Service Bulletin

SUBJECT: Service Update for Inventory and Customer Vehicles
Incorrect Vacuum Pump Fastening Stud Can Lead to Chafing
Expires with Base Warranty

MODELS: 2016 Buick Cascada
Equipped with 1.6L Engine (RPO LWC)

15811A - Service Update - Revision - Incorrect Vacuum Pump Fastening Stud Can Lead to Chafing
Updated Date: Mar 23, 2016 16:40 ET

4454184

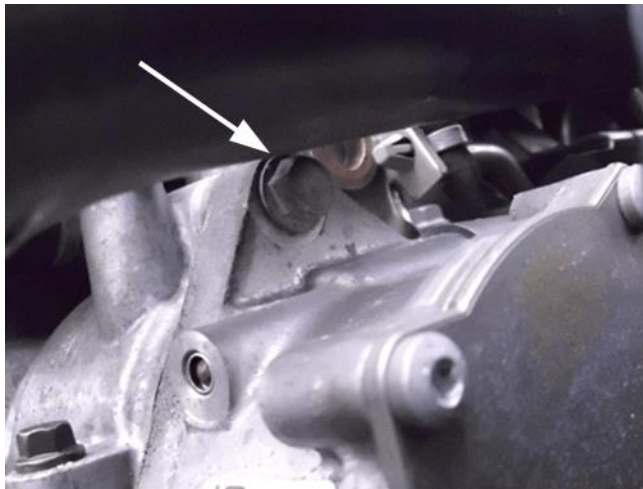
This bulletin provides a service procedure to replace the upper vacuum pump stud with a fastening bolt on **certain** 2016 model year Buick Cascada vehicles equipped with a 1.6L engine (RPO LWC). These vehicles may have a chafing condition of the charge air cooler outlet air hose on the upper vacuum pump stud.

1. Remove and discard the upper vacuum pump stud.

2. Install the new vacuum pump bolt and torque to 10 Nm.
